Rezoning Transportation Analysis

Petition Number: 2020-067

General Location Identifier: Tax ID 09505544

Date	Description
05-18-20	First Review
06-25-20	Second Review (TV)

Reference (CLDSM standard detail U-03A) for street typical.

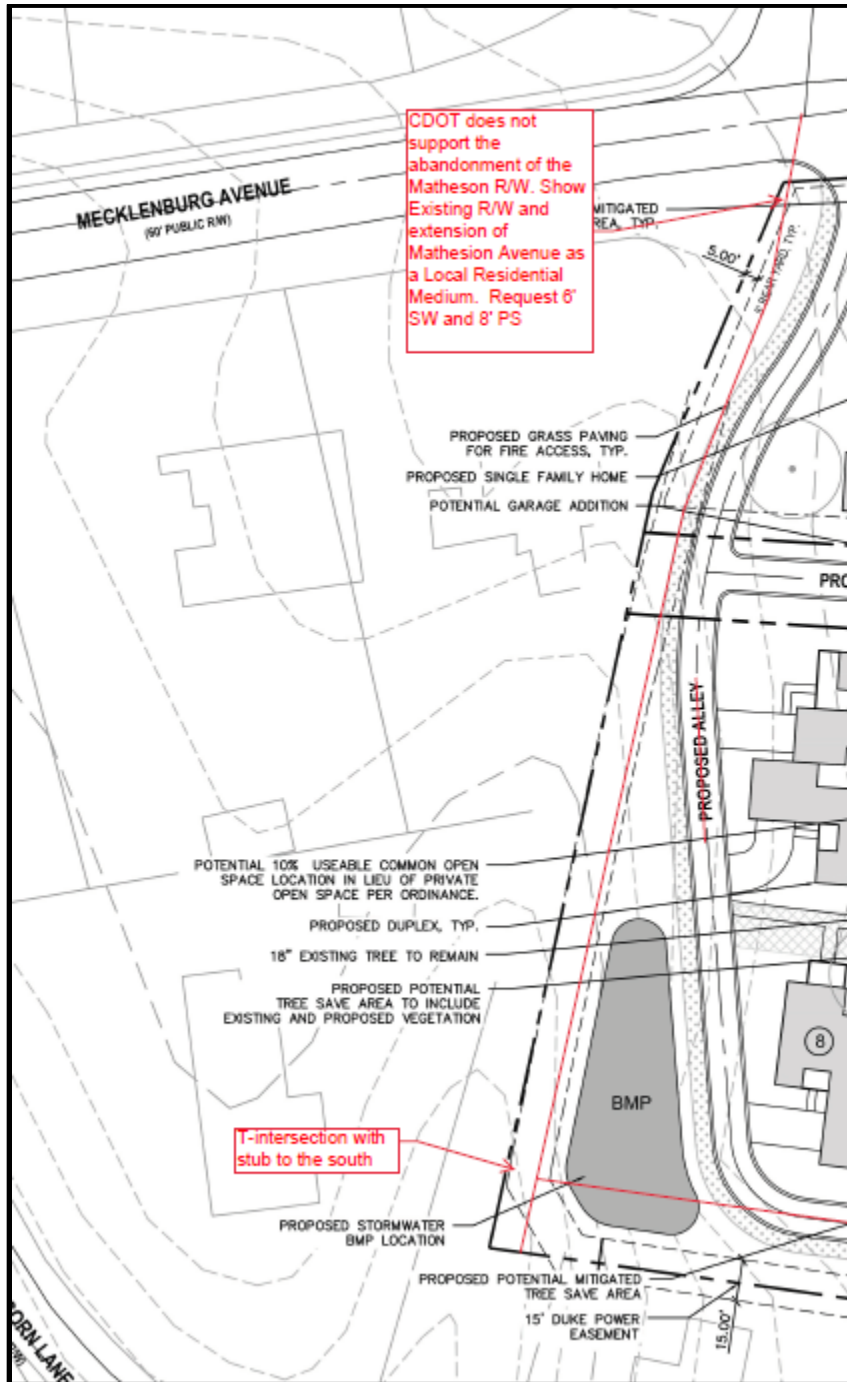
- The petitioner should revise the site plan and conditional note(s) to commit to constructing a public street, Matheson Avenue south of Mecklenburg Avenue, as a Local Residential Medium with an 8-foot planting strip, and 6-foot sidewalk per Chapter 20 Subdivision ordinance.
